P.O.A.D.P. PLAN
for
PROMONTORY POINTE II

Re: Promontory Pointe II Subdivision POADP # 177-B

The City Staff Development Review Committee has reviewed Promontory Pointe II Subdivision Preliminary Overall Area Development Plan # 177-B. Please find enclosed a signed copy for your files. Although your plan was accepted, please note the following:

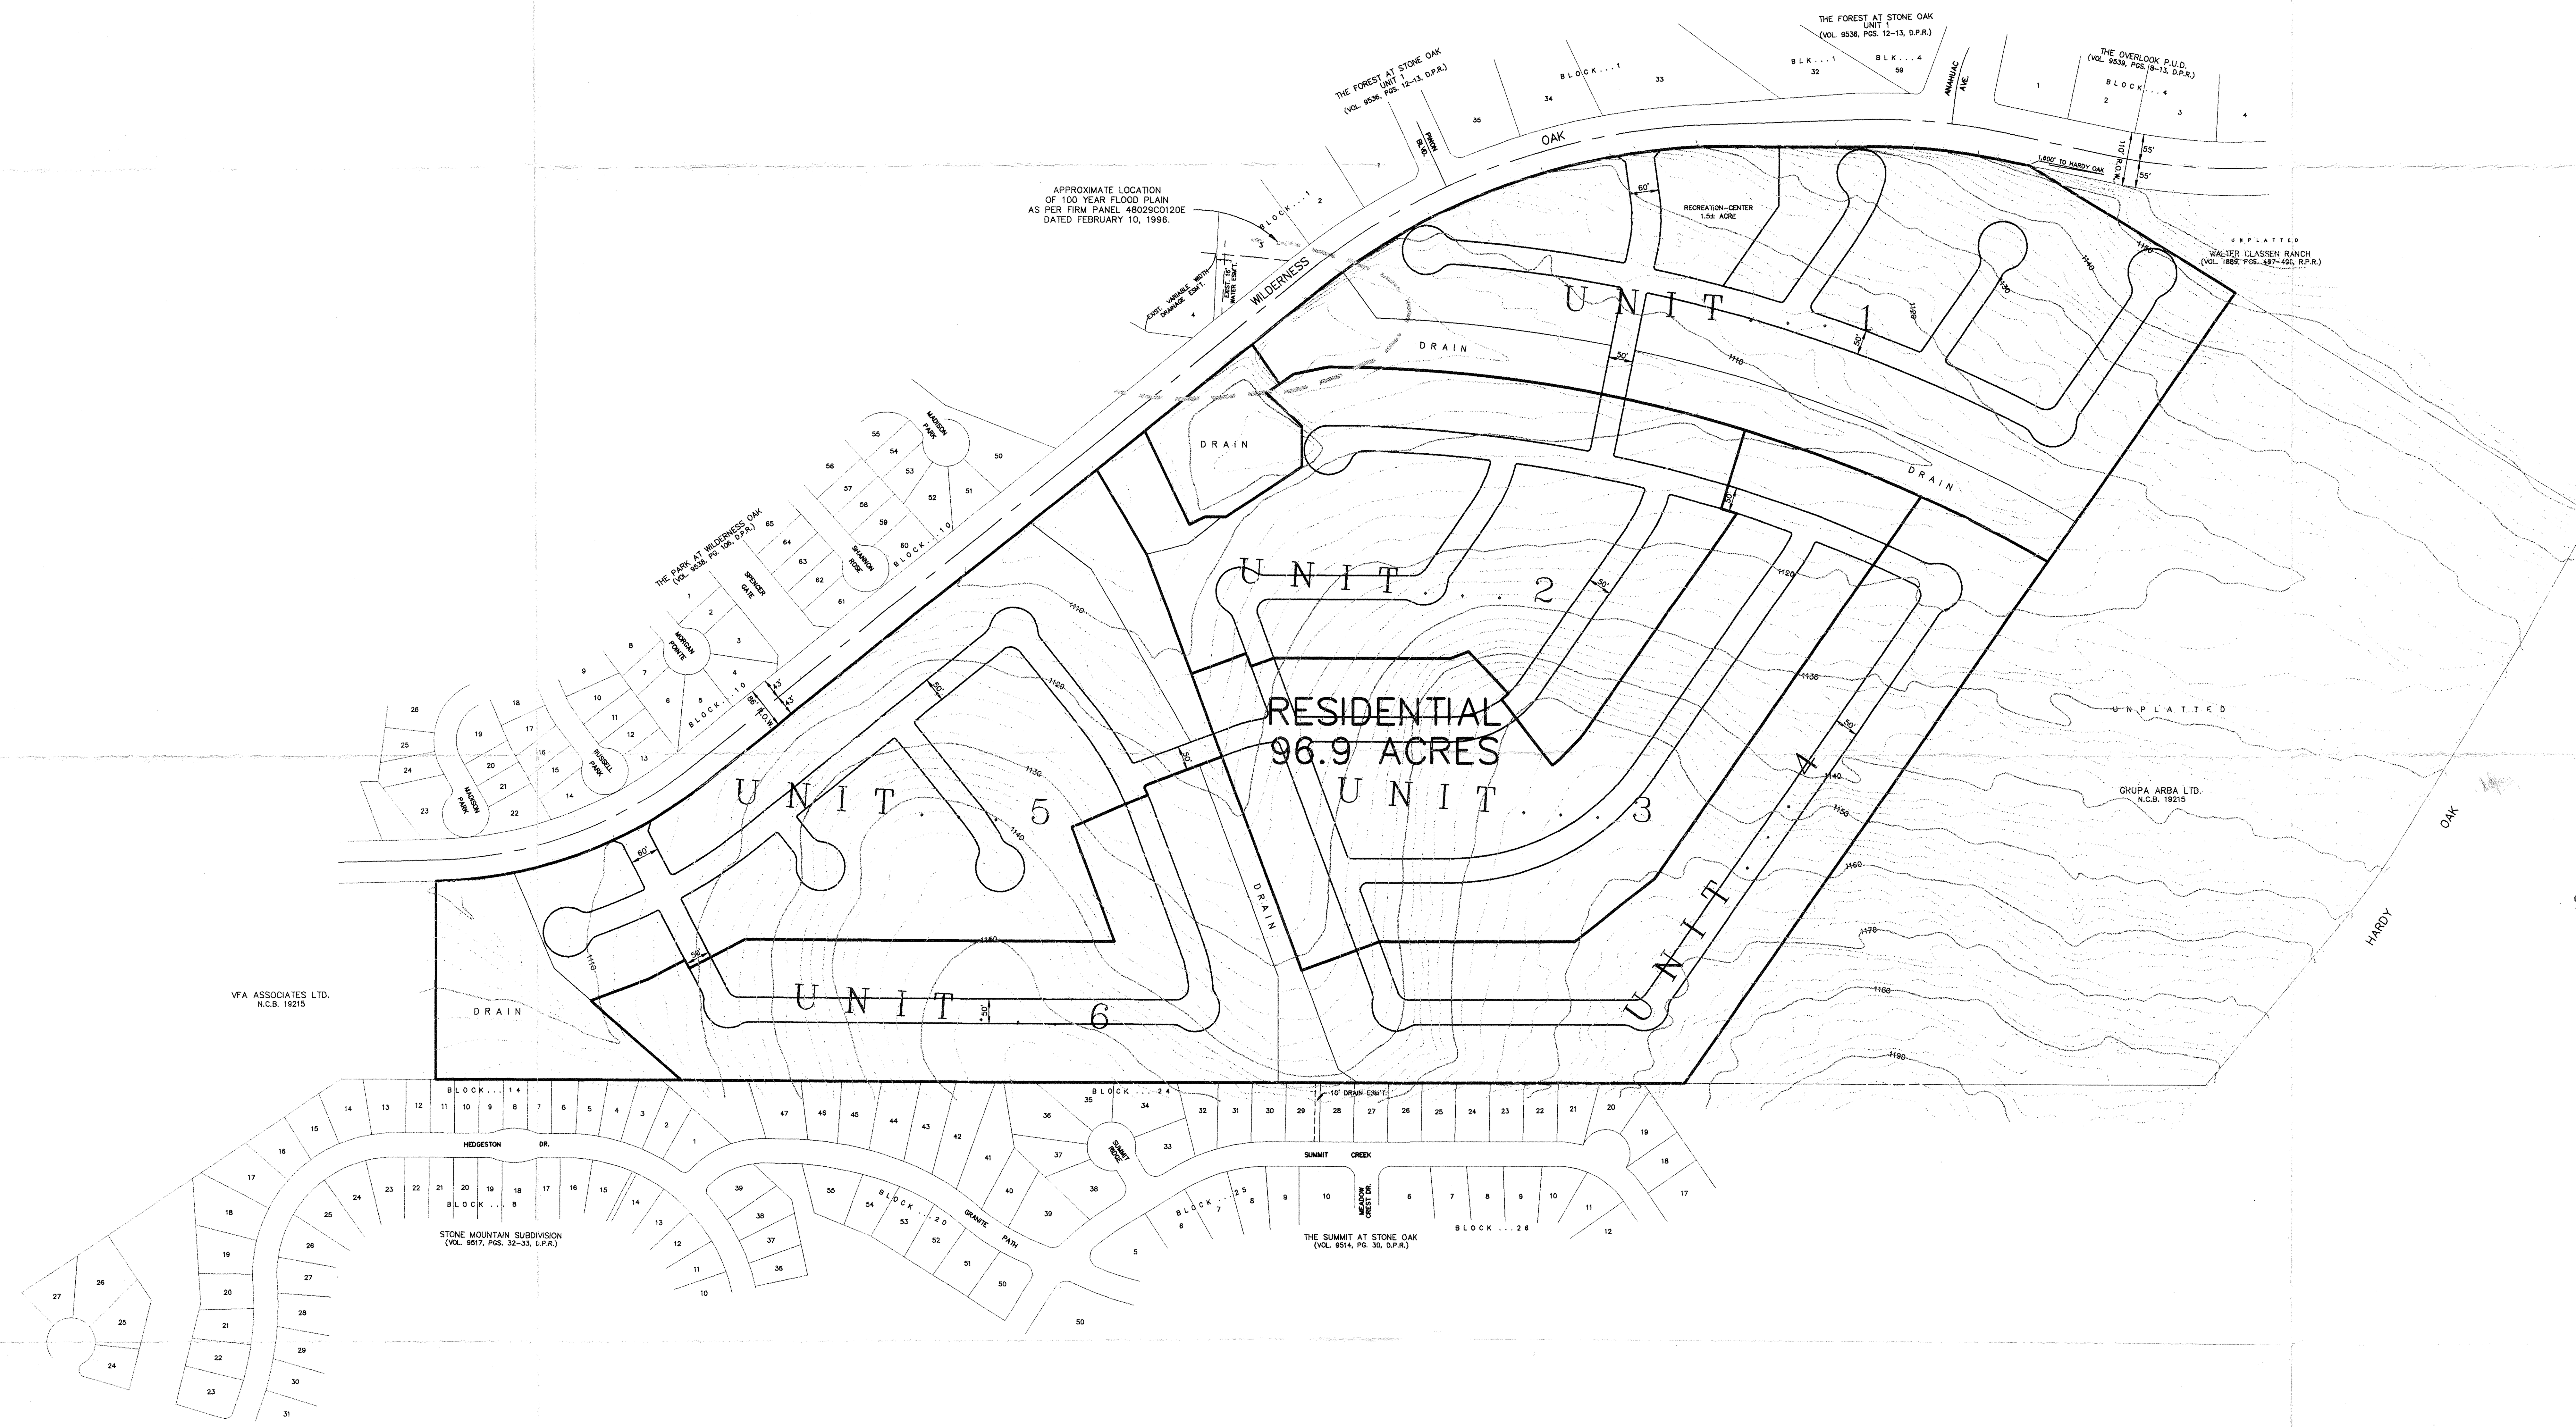
- Based on the topography, a Flood Plain Study and drainage review will probably be required during the platting process.
- In consideration of public safety and convenience, excessive grades by reason of topography should be avoided in street layouts and arrangements.
- This development will probably need to conform to requirements associated with development over the Edwards Aquifer. For additional information about these requirements you can contact SAWS at 704-7305.
- This development will need to comply with tree preservation ordinance #85262. For information about these requirements you can contact Building Inspections at 207-7102.
- It will be expected that you will plat all of the property depicted in your POADP, to include: floodpains, drainage areas and open space.
- I would encourage you to work closely with the school district, so that they can plan accordingly.
